SUBJECT: PILOT-SCALE RECHARGE REPORT AND 2012 RECHARGE PLANS

**DATE:** JUNE 5, 2012

## **Pilot-Scale Demonstration Project Report**

ATTACHMENT A 6/5/2012

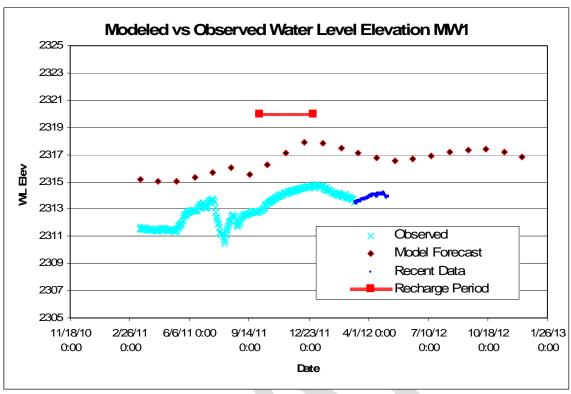
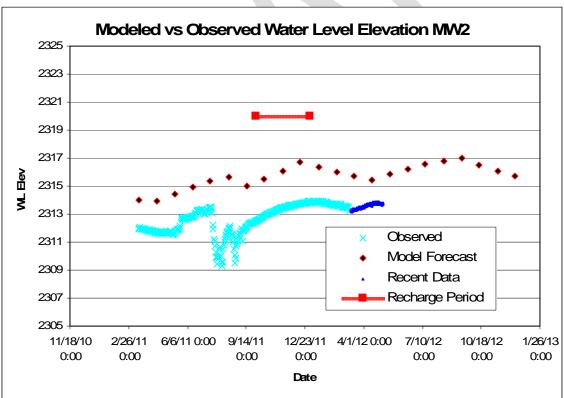
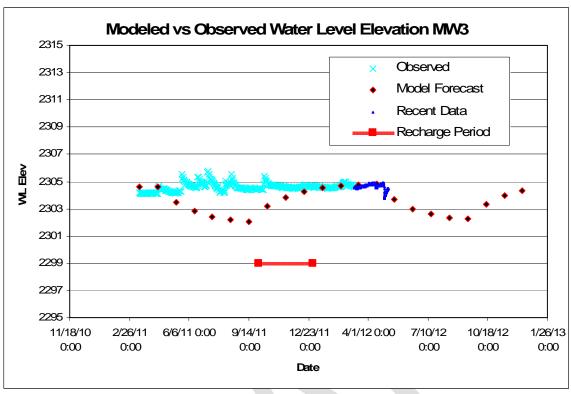
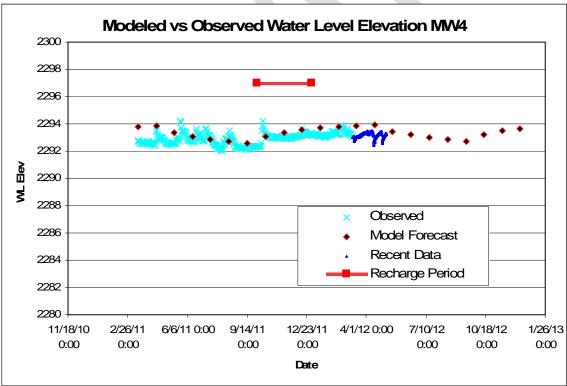
- 3) Groundwater levels were unusually high prior to the pilot recharge project. Water levels recovered to near pre-project conditions over the winter months, and in some cases have started to increase in response to springtime irrigation operations (Attachment A). Given the current below-average runoff conditions, groundwater levels are expected to be lower in fall 2012 than they were at the beginning of the pilot recharge project. This condition could allow an extended recharge period during the 2012-2013 non-irrigation season.
